**DEFENSE NUCLEAR FACILITIES  
SAFETY BOARD**

**RECOMMENDATION 2015-1 TO THE SECRETARY OF ENERGY**  
***Emergency Preparedness and Response at the Pantex Plant***  
**Pursuant to 42 U.S.C. § 2286a(b)(5)**  
**Atomic Energy Act of 1954, as Amended**

**Dated: November 23, 2015**

Figure 3. Structural Fire EAL

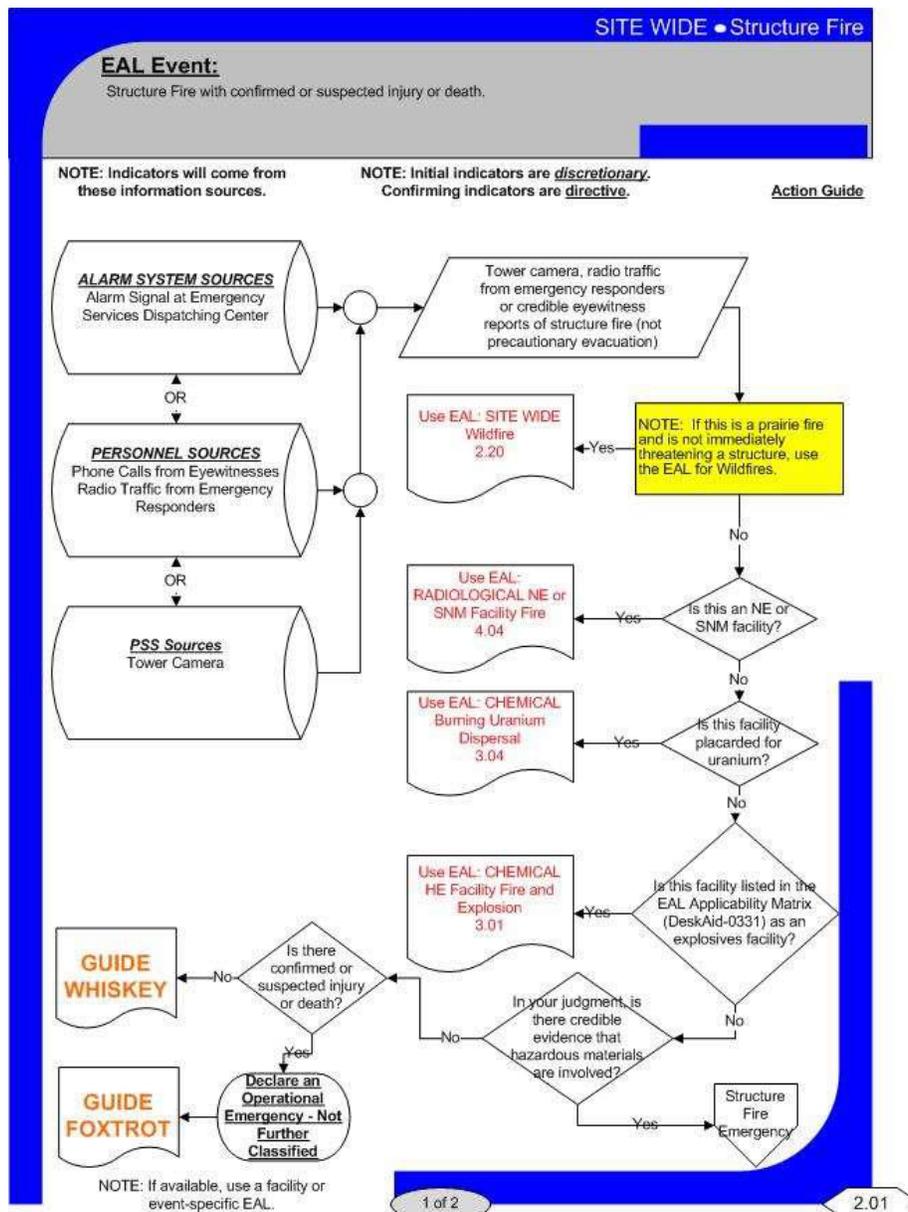
Pantex Plant emergency management personnel chose to use a decision tree model in their EALs, visually guiding an operator through decisions being made in response to an event on site. The example in Figure 3 below, taken from the Pantex EALs [12], shows the flow-path through decision making to action.

An operator—in the case of the Pantex Plant, the PSS—enters the EAL with relevant information concerning an emergency event. This leads the PSS to a conservative emergency categorization and classification. These classifications (Alert, Site Area Emergency, and General Emergency) ensure appropriate responses are taken given the anticipated magnitude of the accident consequences. In most radiological EALs at the Pantex Plant, the PSS receives initial information of emergency conditions from an instrumented signal. For example, coincident fire and radiation monitor alarms would indicate the presence of a possible fire with radioactive material release.

Figure 4. NE or SNM Facility Explosion

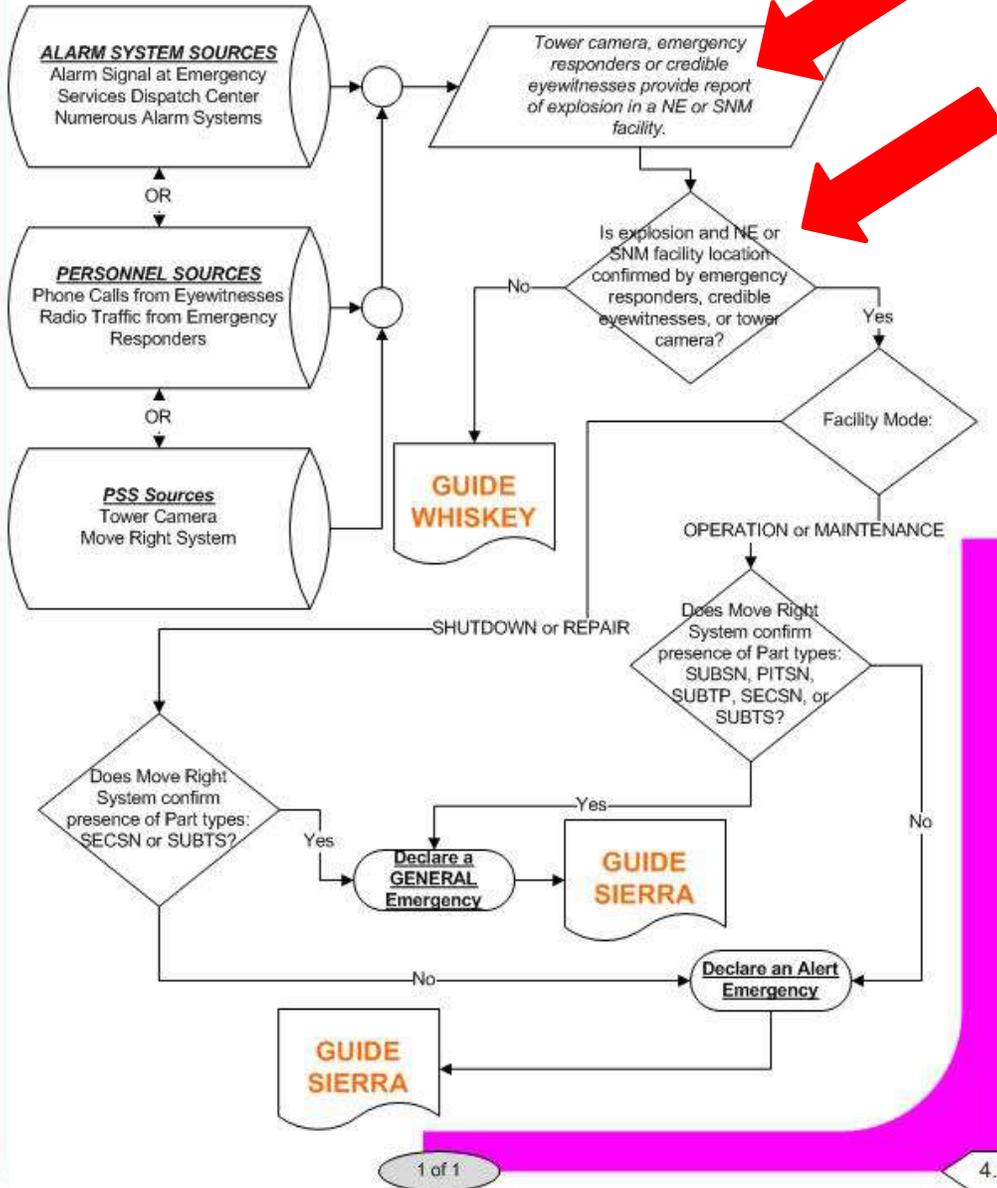
These classification decisions allow the PSS to determine what, if any, protective actions are necessary for personnel on site and recommended protective actions for the public off site. Waiting for confirmation from first responders, if not provided by some other source, may cause a delay in the PSS issuing notifications and recommendations for protective actions to the workforce and the public. For example, in the following EAL, if no confirmatory information is provided, someone must be dispatched to confirm if an explosion truly occurred [12].

Figure 5. NE or SNM Facility Fire EAL

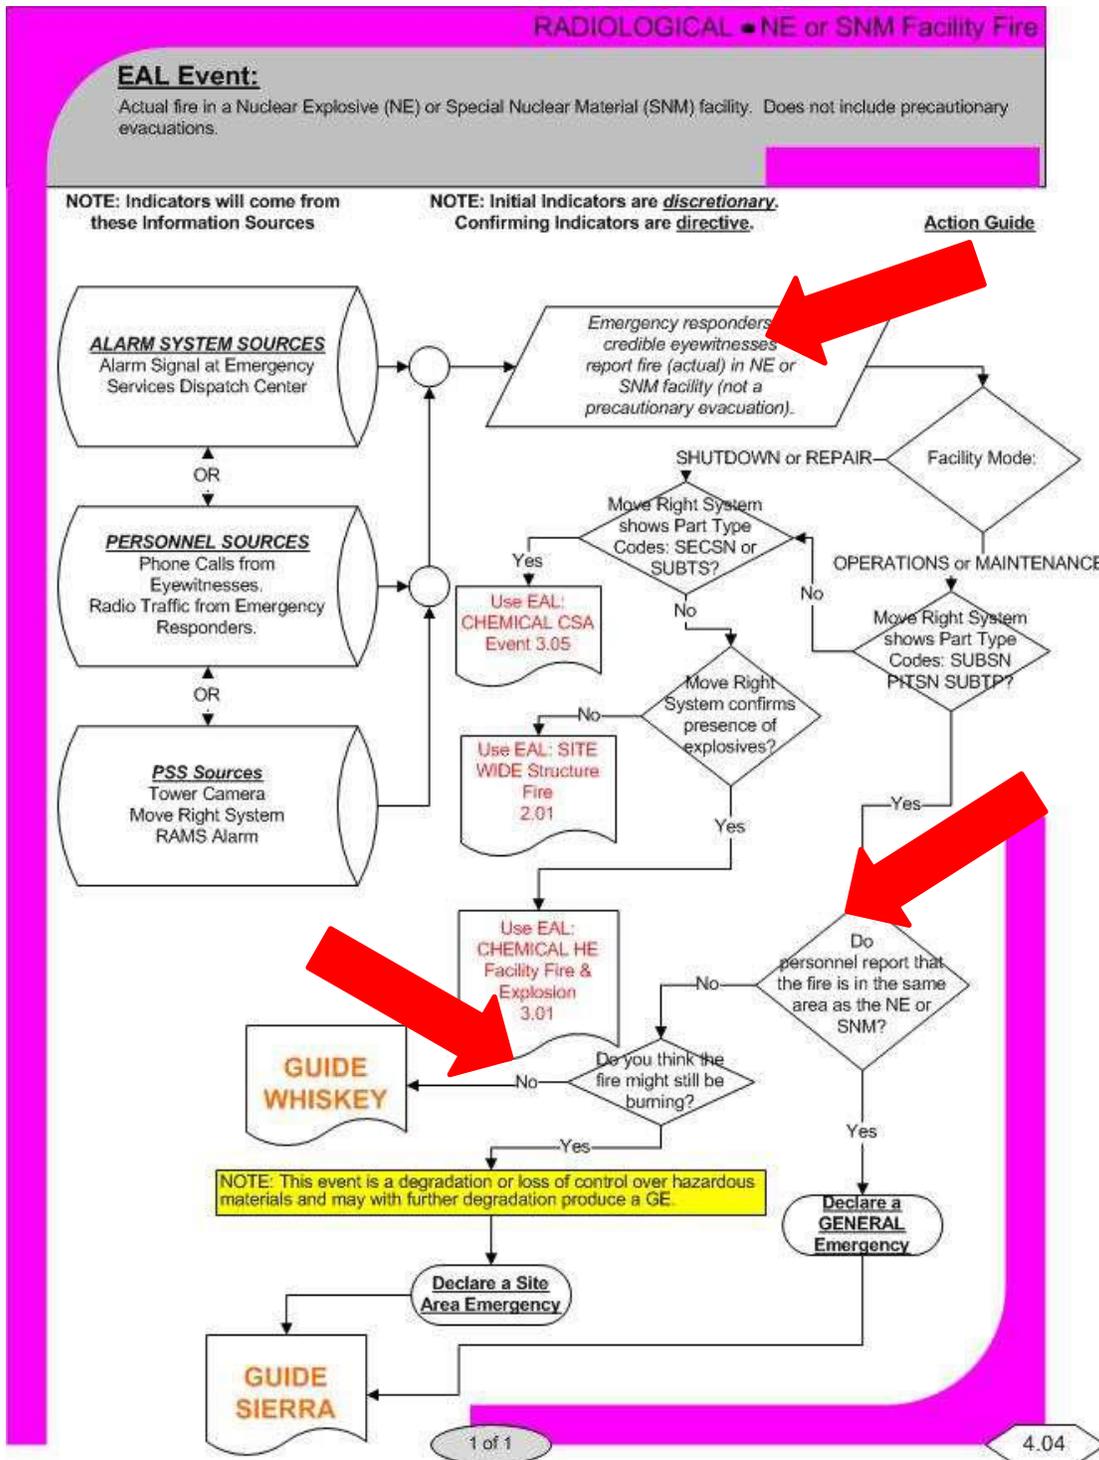
Similarly, note the reliance on personnel observations and inferences to assist the decision maker through appropriate classification of a fire in a nuclear explosive or special nuclear material facility [12].

Figure 6. Tritium Release EAL

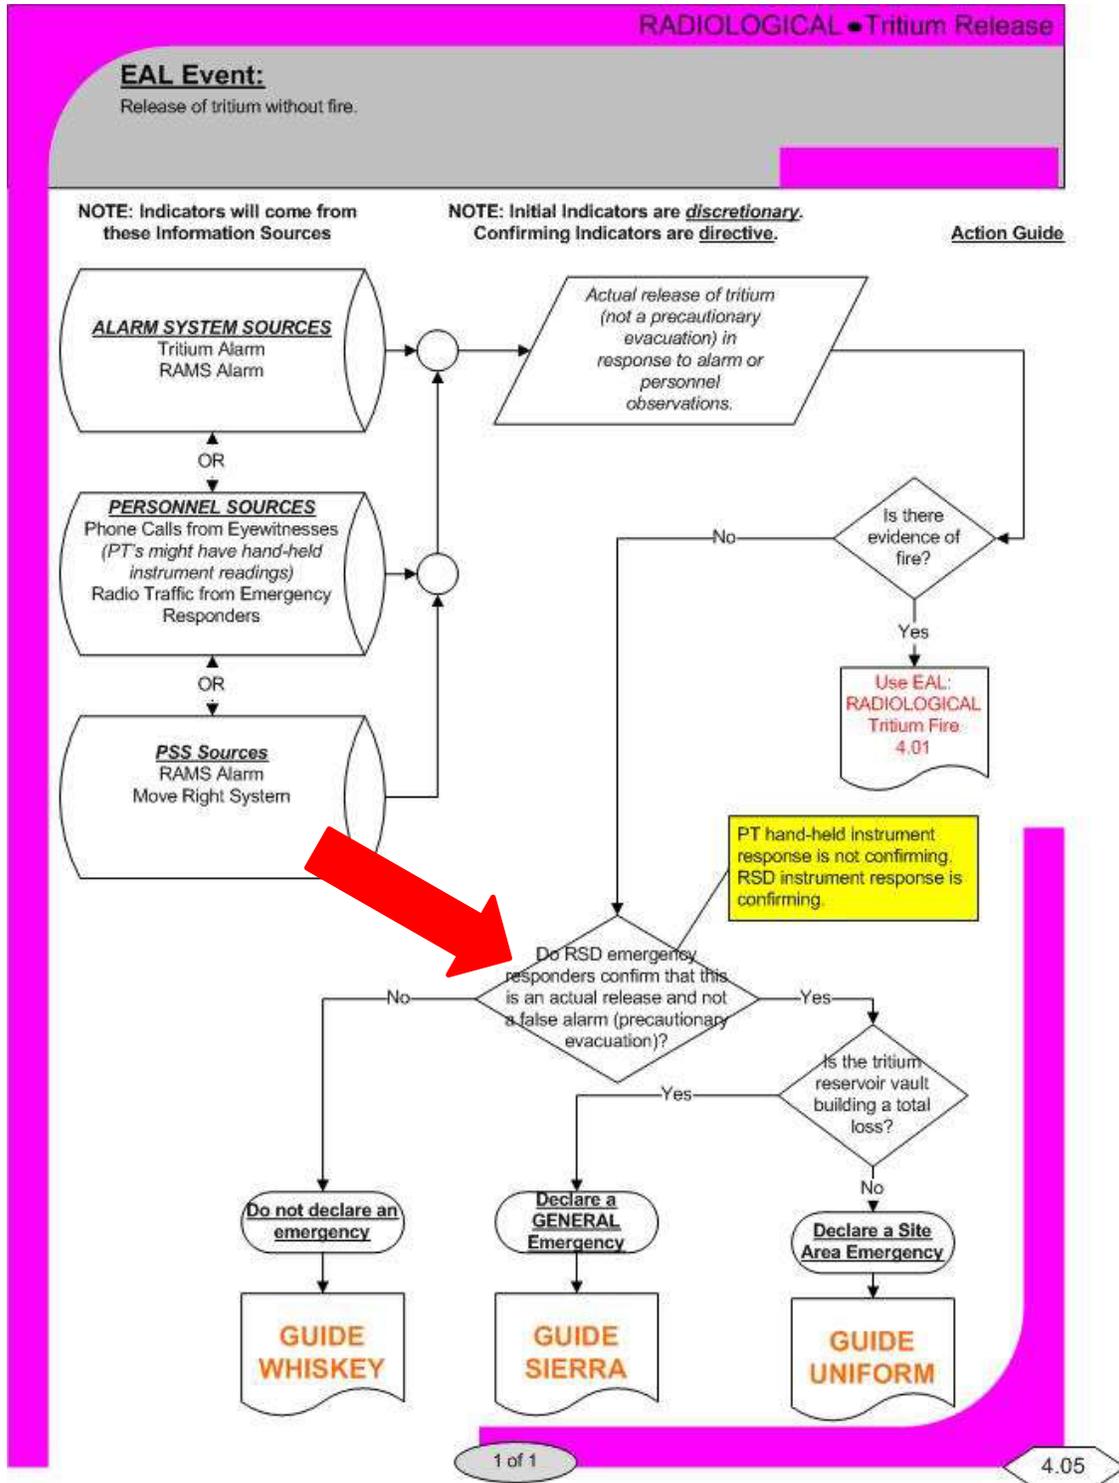
In the following example, radiological support personnel must be dispatched, if not immediately available at the scene, to confirm the validity of a tritium release alarm before the appropriate emergency classification and protective actions are determined [12].

Figure 7. Tritium Fire EAL

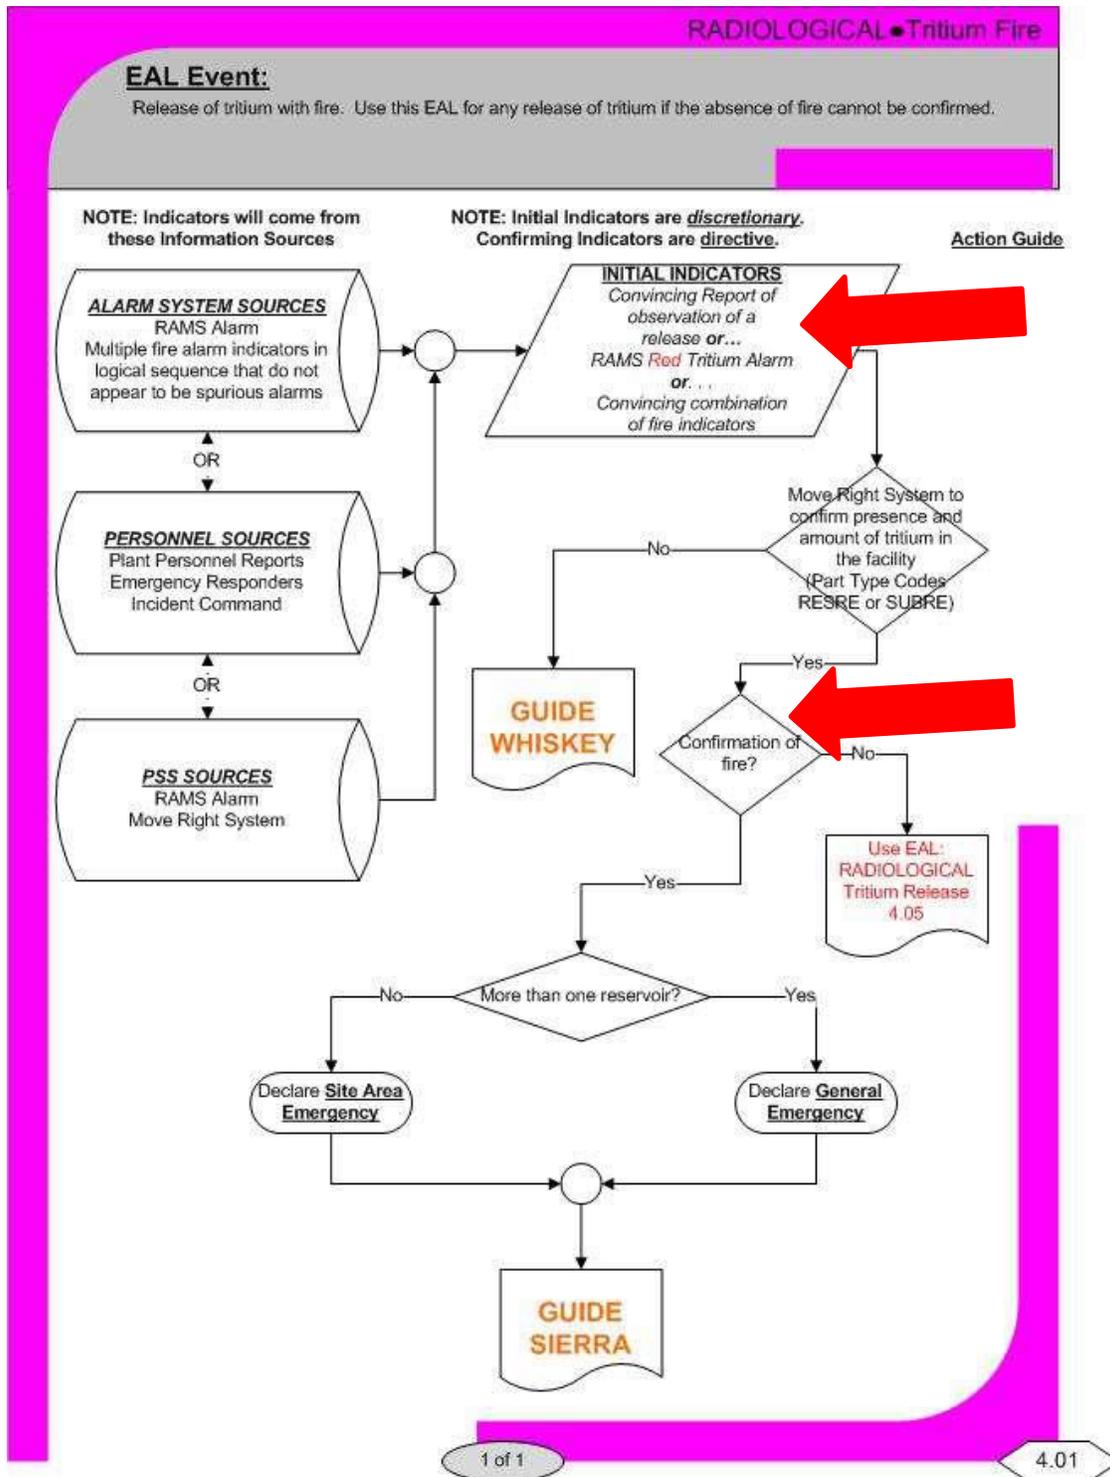
In the following example, it is not clear what a “Convincing Report” or combination of fire indicators is without further training or guidance on expectations for those who may report such events [12].
